ADDENDUM No.1

PROJECT NAME: BELL MANOR ELEMENTARY SCHOOL REPLACEMENT

CLIENT NAME: HURST-EULESS-BEDFORD I.S.D.

PROJECT NUMBER: 1906-01-01

TECHNOLOGY SITE PLAN

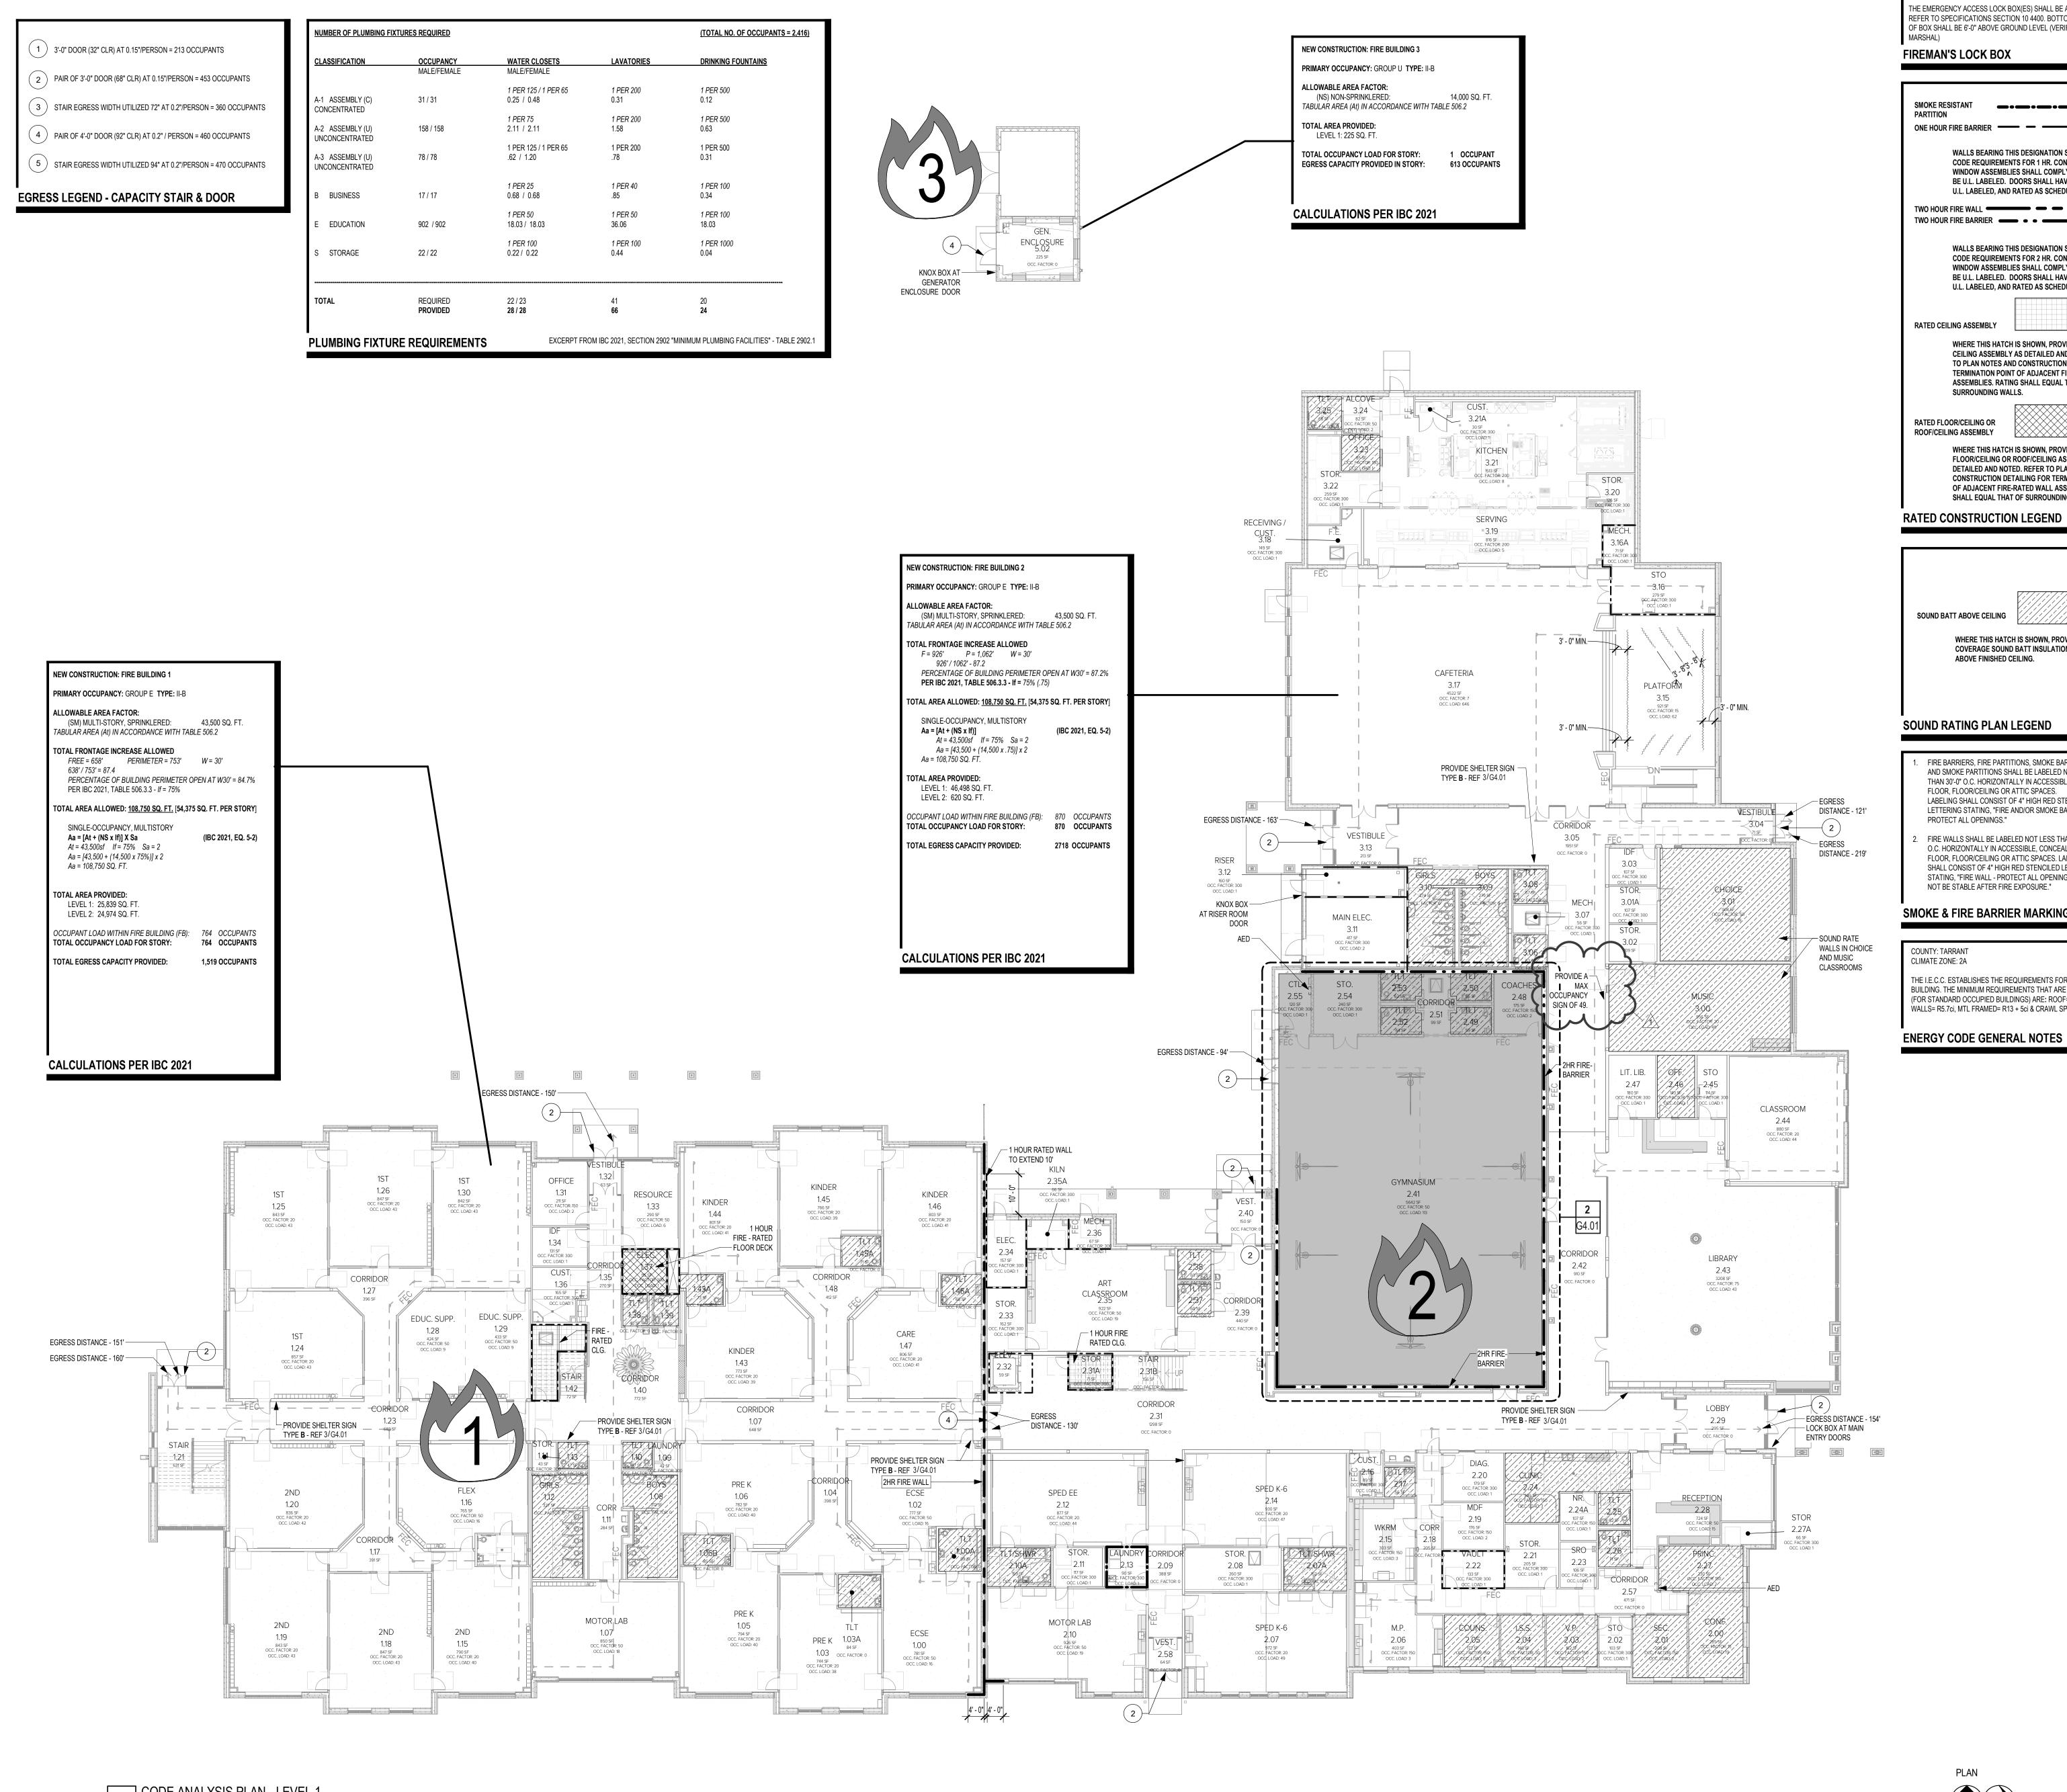
AD No 1, Tech. Item 1: To the Drawings, Sheet T1.00, "TECHNOLOGY SITE PLAN,"

- 1) Added "TECHNOLOGY KEYED NOTES" #8 #14.
- 2) Revised site plan as shown.

8 PROVIDE AND INSTALL ONE (1) 30"X 36"X48" PULL BOX, AT THE LOCATION INDICATED. PULL BOX
SHALL BE INSTALLED WITH THE TORSION SPRING ASSISTED COVER AT GRADE LEVEL, CLEARLY MARKED "COMMUNICATIONS", AND SHALL BE LOAD RATED IN ACCORDANCE WITH THE LOCATION IN WHICH IT IS INSTALLED.

13 APPROXIMATE LOCATION OF NEW IDF 1.34 14 APPROXIMATE LOCATION OF NEW IDF 3.03

ELECTRICAL RISER DIAGRAM AND PANELBOARD SCHEDULES

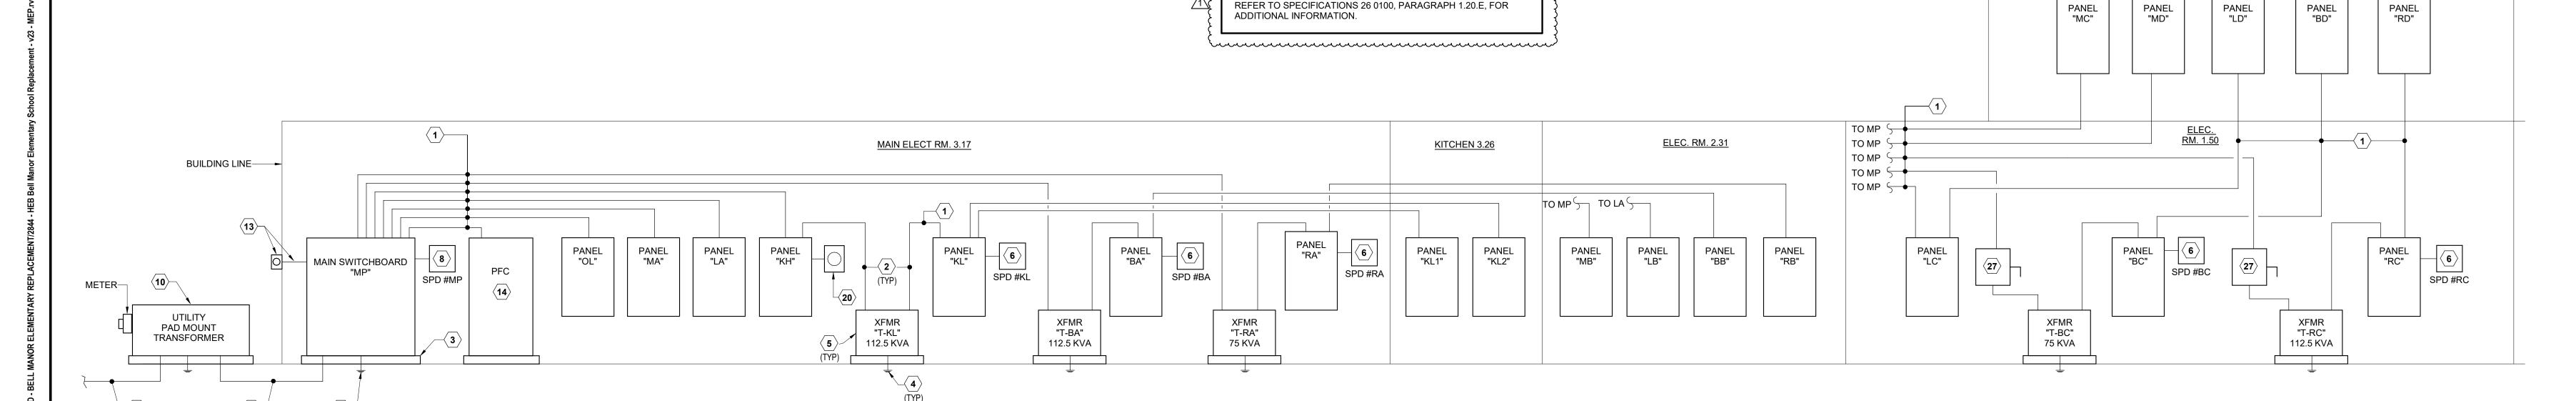
AD No 1, Elec. Item 1: To the Drawings, Sheet E1.06, "ELECTRICAL RISER DIAGRAM AND PANELBOARD SCHEDULES,"

1) Added note to riser diagram for service equipment available fault current labeling.

C. SERVICE EQUIPMENT SHALL BE LABELED WITH AVAILABLE FAULT CURRENT PER N.E.C. ARTICLE 110.24 REQUIREMENTS.
